**Subject:** Follow up on Request for Additional Information on "EPRI MOV Performance Prediction Program: Addendum 10 to EPRI 103237-R2: PPM Version 4.0 Software Changes"

**Project Number: 689**

**EPRI Responses to  
NRC Request for Additional Information Regarding  
Addendum 10 to EPRI 103237-R2: PPM Version 4.0 Software Changes**

**GLBM Test Case 26**

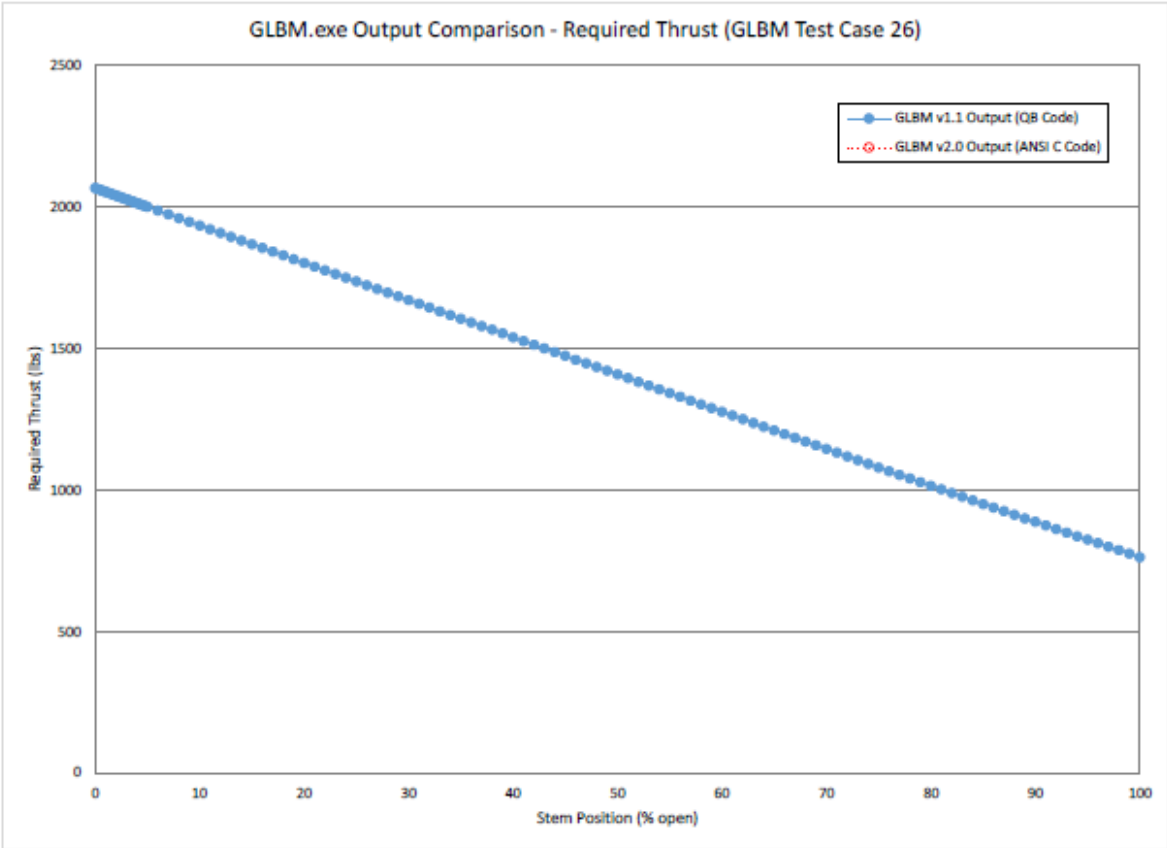
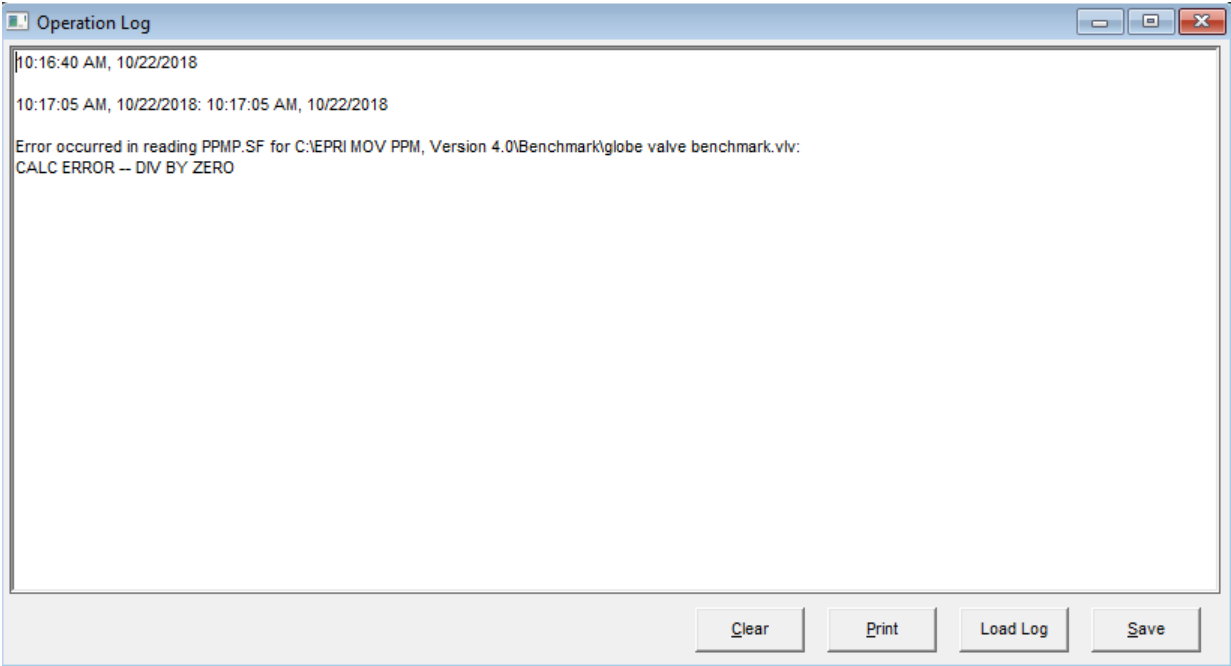
- **GLBM Test Case 26: Balanced disk, rising-stem globe valve with flow over-seat (with the stem pitch and roll angles both at 90°)**

Note: For this test case, Version 3.5 (GLBM v1.1) generates the results shown, and Version 4.0 (GLBM v2.0) issues a “division by zero” error message (see attached) and does not perform a prediction. Because of a known issue in the legacy code, Version 3.5 generates results if both the stem pitch and roll angles are set to 90°, a configuration that is not physically possible. The cause of this issue was related to the conversion of 0° to radians, which resulted in very small, but non-zero, angles. This issue has been corrected in Version 4.0, and as a result an error message is generated so that the user can correct the inputs and re-run the prediction.

### SFM Test Case 8

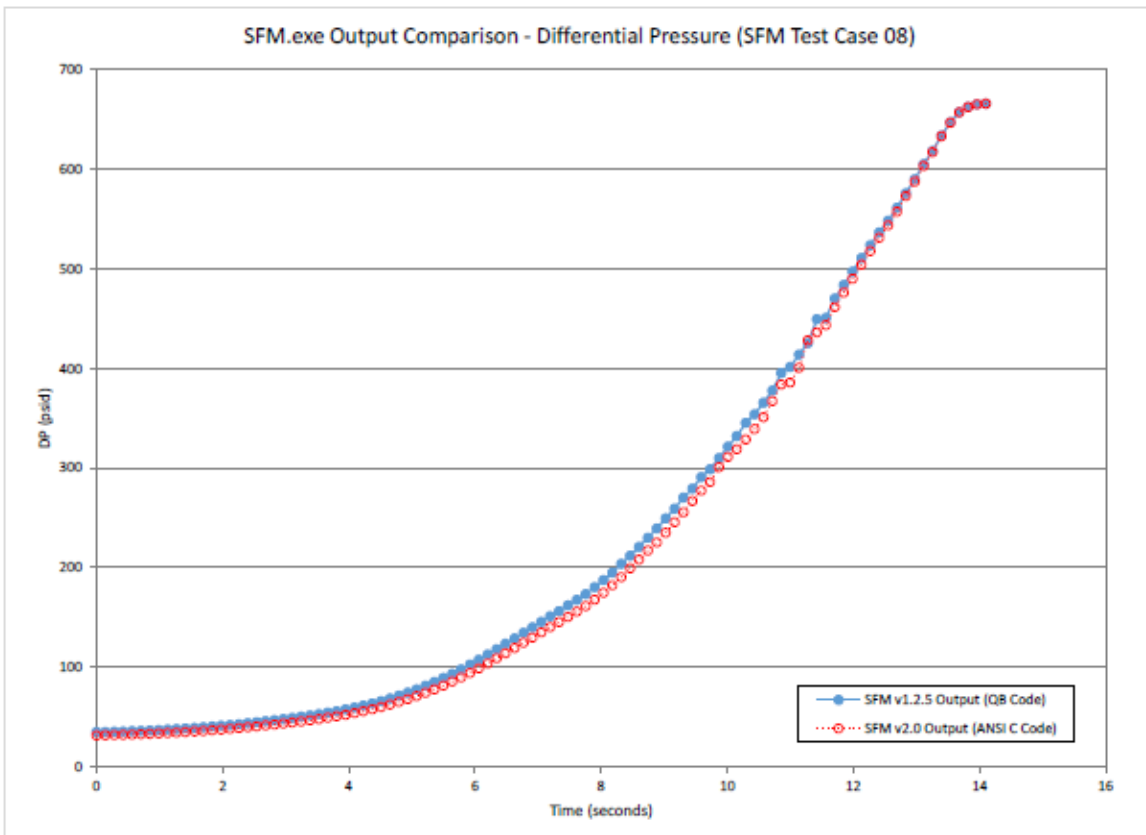
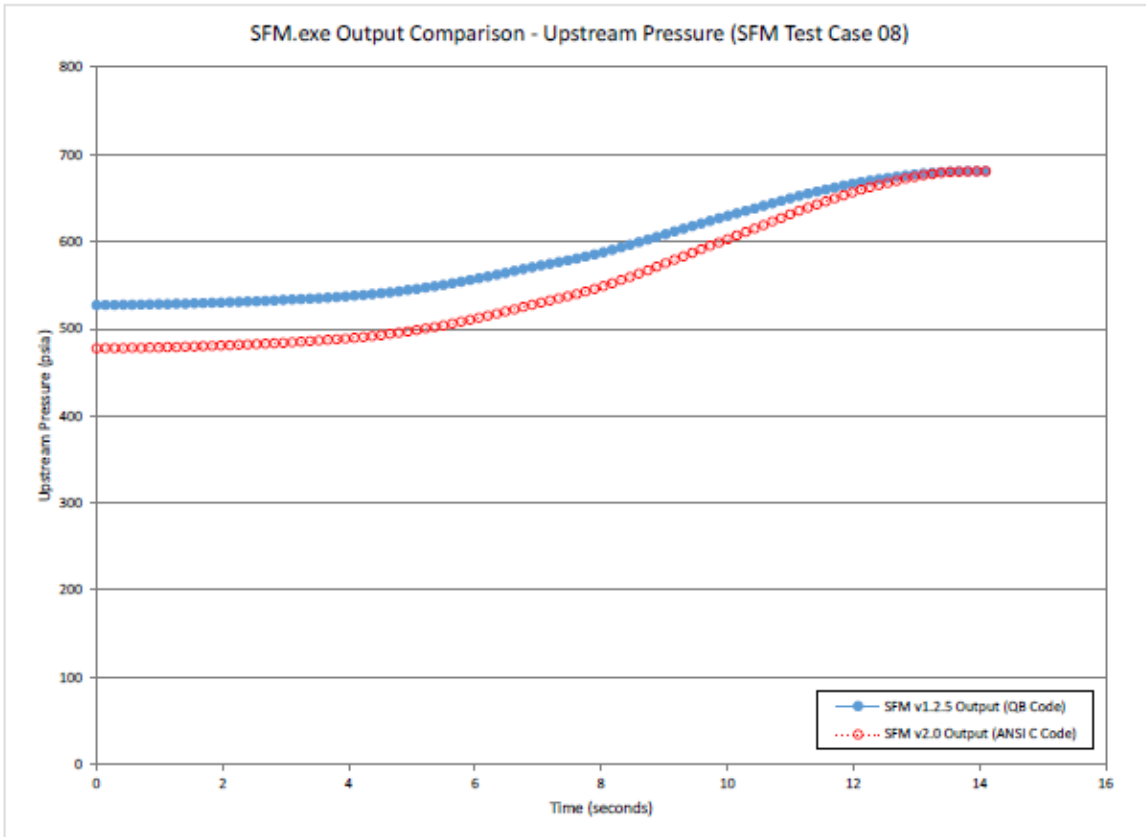
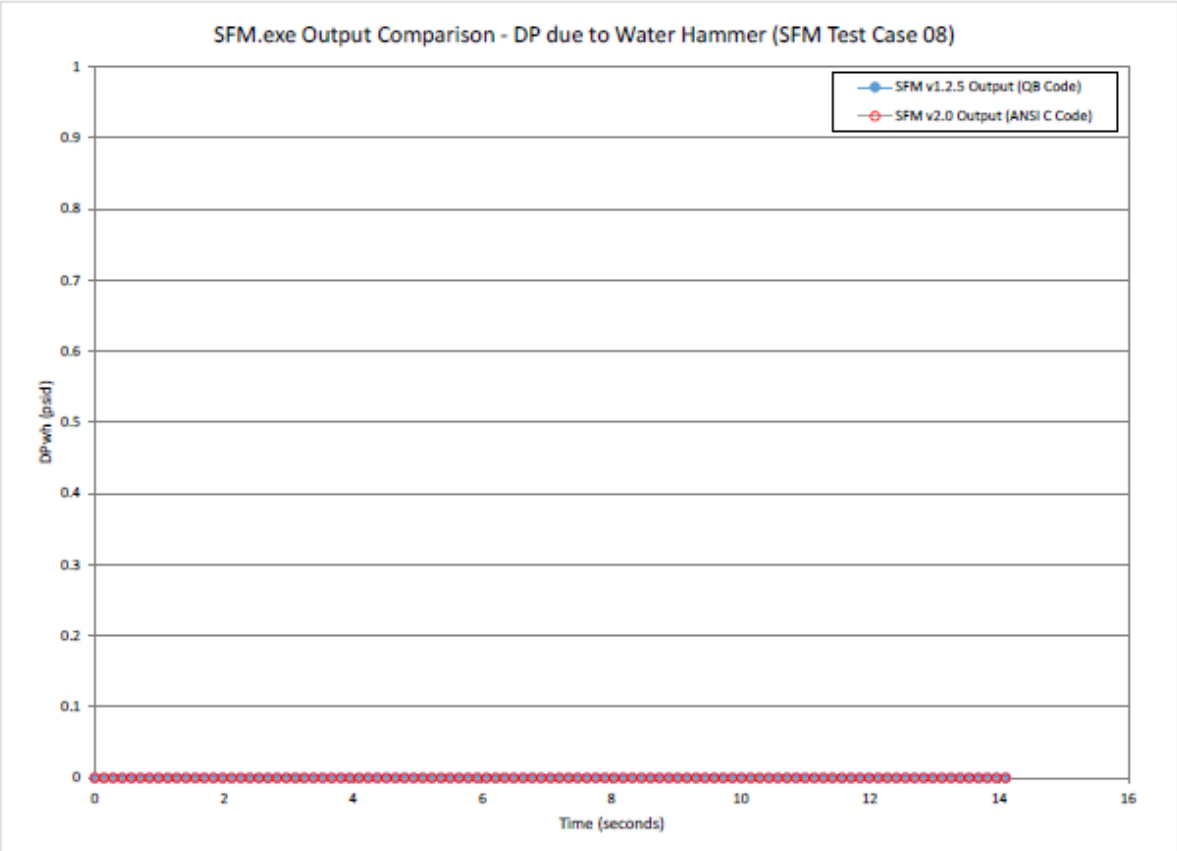
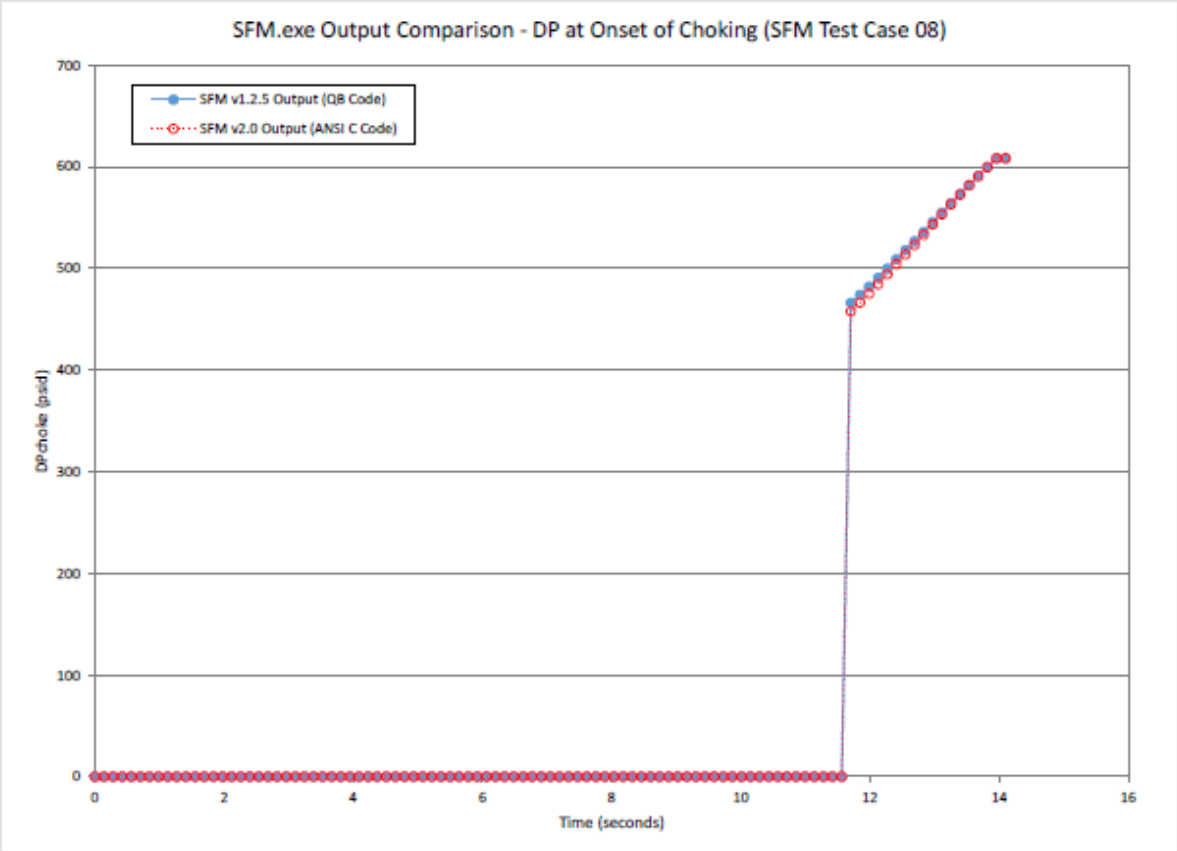
- **SFM Test Case 08: Full System Flow Model analyzing a gate valve stroke with two-phase fluid under blowdown conditions**

Note: The differences between Version 3.5 (SFM v1.2.5) and Version 4.0 (SFM v2.0) are the result of correcting an error in the legacy code.

**SFM Test Case 4**

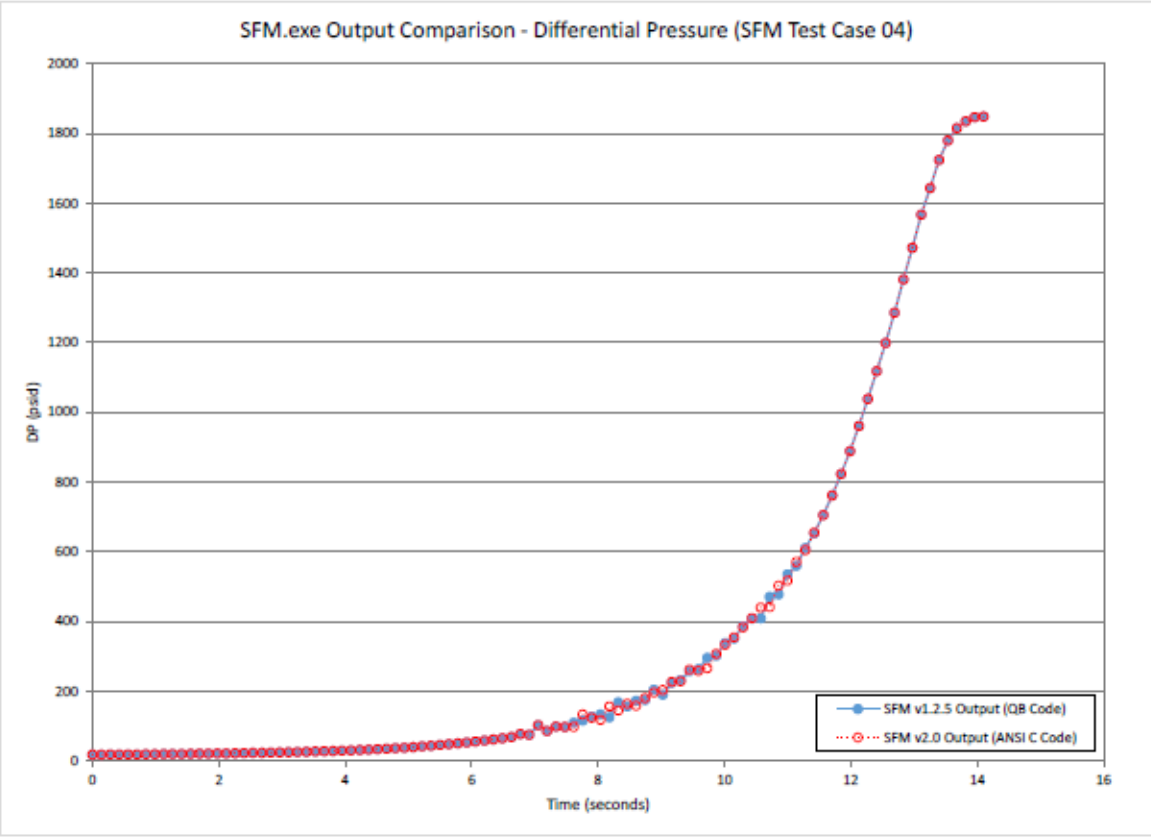
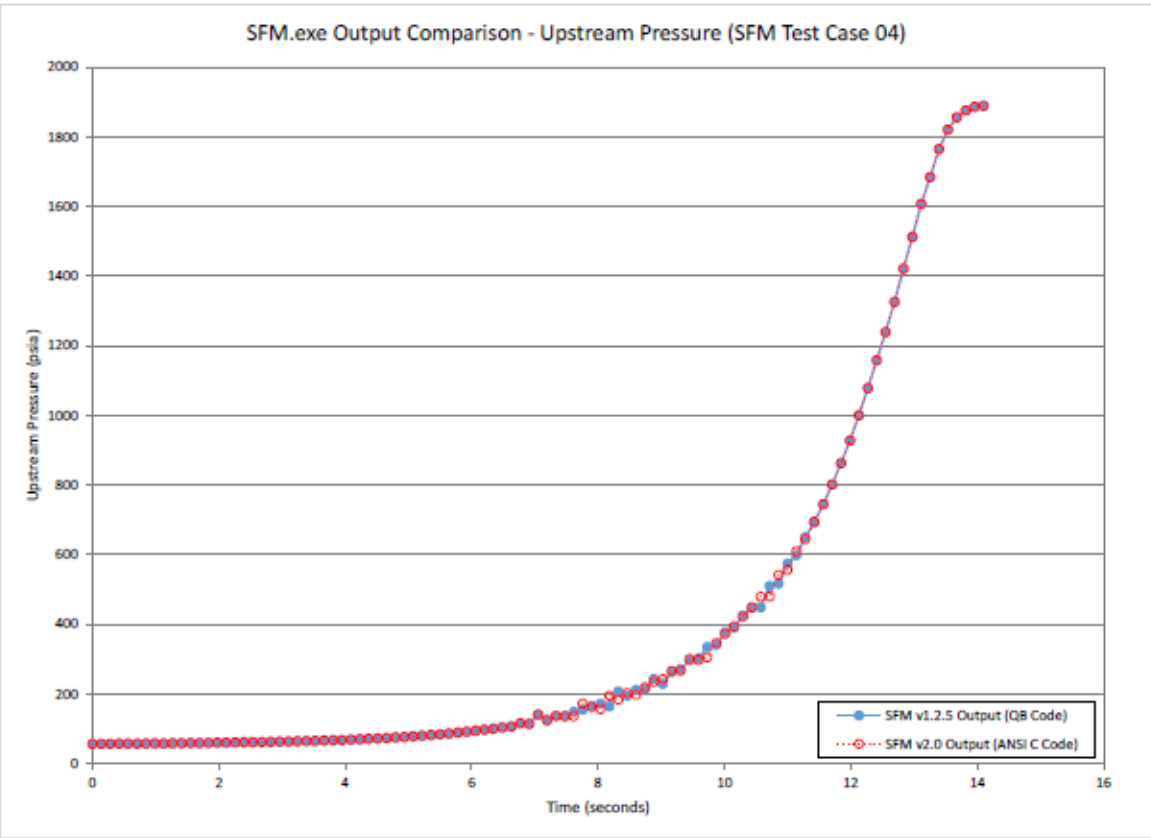
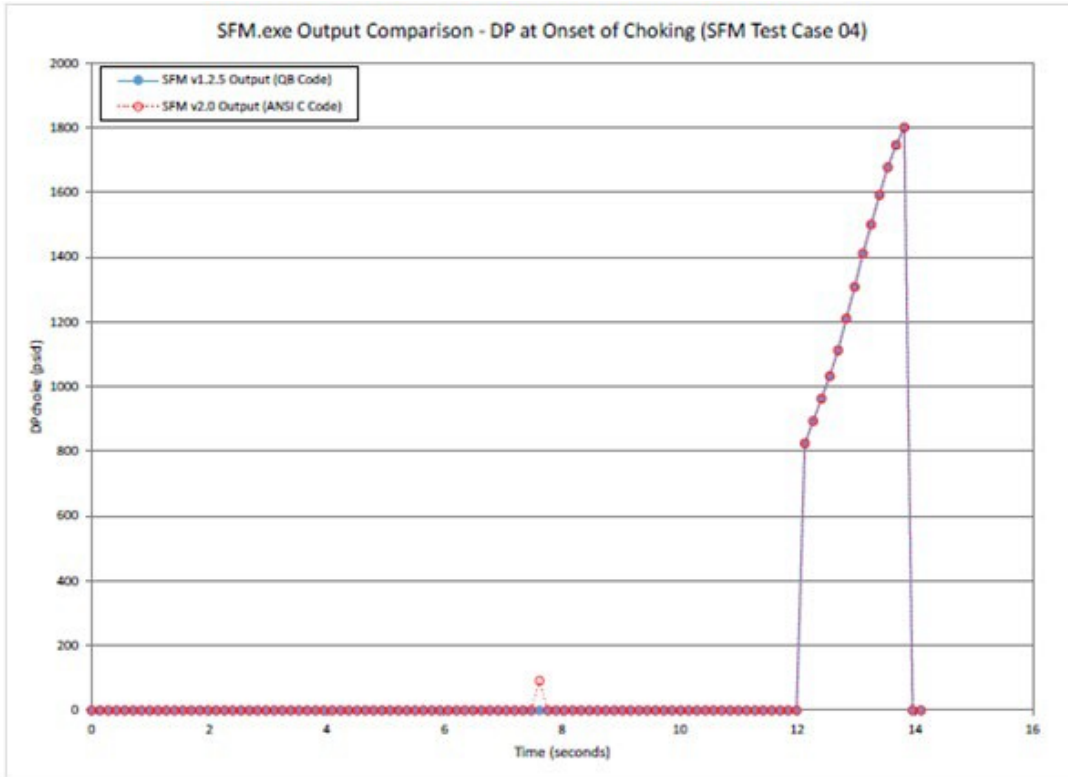
- **SFM Test Case 04: Equivalent Resistance Method analyzing a gate valve stroke with cold, subcooled water under high flow conditions**

Note: The differences between Version 3.5 (SFM v1.2.5) and Version 4.0 (SFM v2.0) are assessed to be the result of differences in the math processors used by the Microsoft Quick Basic (Version 3.5) and ANSI C (Version 4.0) compilers. The differences are negligible and do not significantly affect the overall thrust or torque predictions.

Note: The difference in the above plot at 7.5 sec. is the result of SFM v2.0 predicting conditions just past the threshold for choked flow (and displaying a choke-limited DP), while SFM v1.2.5 predicted conditions just below the threshold for choked flow (and displaying 0 to indicate non-choked flow). The actual difference in predicted DP is small and is displayed in the prior plot.
